Technical Information

Subject: **Ignition switch wire relocation**

Product: **LXP 950 Orioli \ Enduro Veloce**
All affected VINs are linked in Dealer.net

Following continuous monitoring of the quality of our product, it has been found that on the above vehicles it is necessary to change the routing of the wires coming out of the ignition block aimed to reduce the stress on the wires during the steering operations.

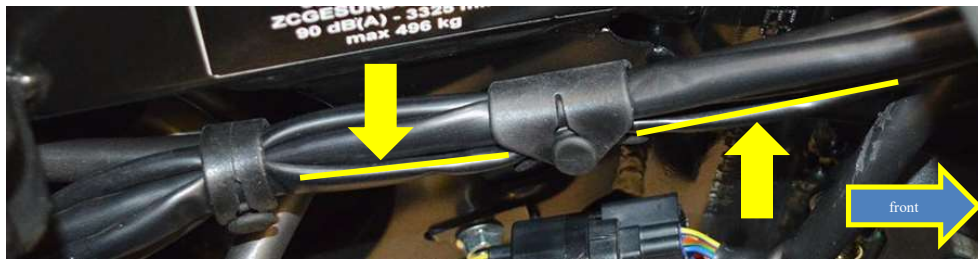
- Remove the rubber tie placed in direction of the front of the vehicle on the wiring and remove the protective sheath; **the protective sheath will not be reused:**

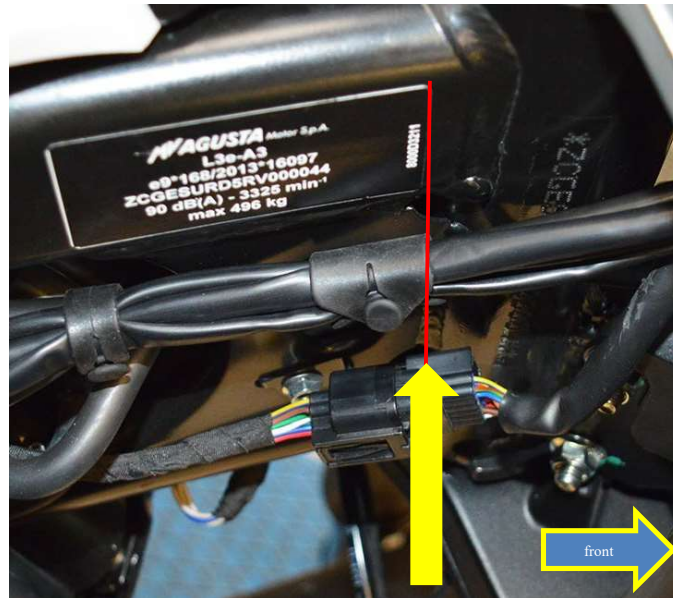
- Move the steering full left.
- With the steering in full left position, you will need to **slide\move the antenna wire as much as possible towards the rear of the vehicle**, reducing at maximum the cable length in excess in the front side of the vehicle.
- Reposition the previously removed rubber tie in the position indicated in the picture; the ideal position is in correspondence of the right edge of the VIN label or 40 mm from the steering head:

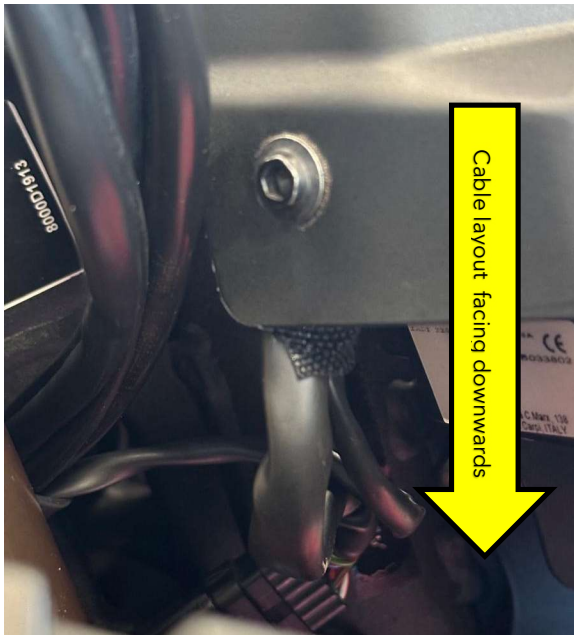
- **Make sure that the bends of the cables coming out of the ignition switch are wide, without constriction points or excessive tight bends.**
- Make sure that the antenna wire passes **below all the other wires present**.
- Locate and disconnect the ignition switch connector.
- Rotate the ignition block side-end connector **one turn clockwise** to pre-load the cable and help it keeping the right position. Before re connecting, rotate the ignition switch lead connector so that the wiring faces the steering head.

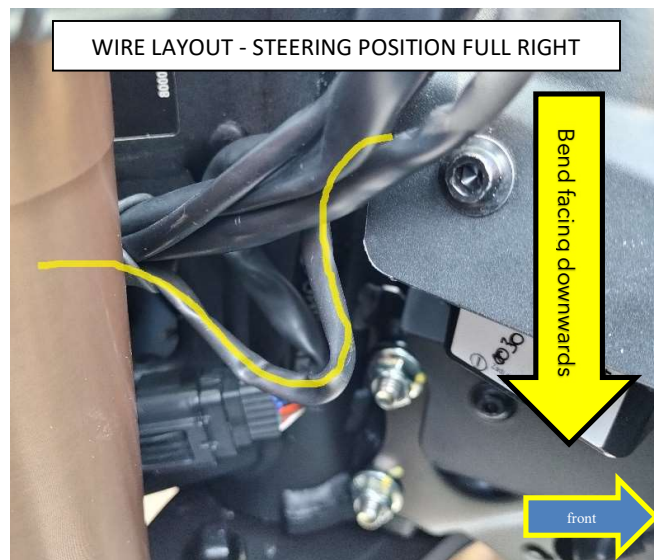
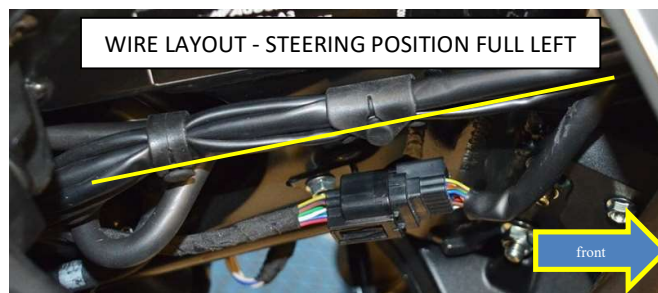
- Reconnect the ignition switch cable and keep it separated from the wires heading to the rear end of the vehicle.
- Check that the wiring coming out of the ignition switch is oriented downwards. Otherwise, it will be necessary to reposition it by changing the orientation of the cable guide located under the ignition switch cover in order to have the cable pushed downwards:

- The basic target is to obtain, with the steering assembly in its full right position, a wide and round bend on the antenna and ignition switch cables, with the bent part of the wire facing downwards:
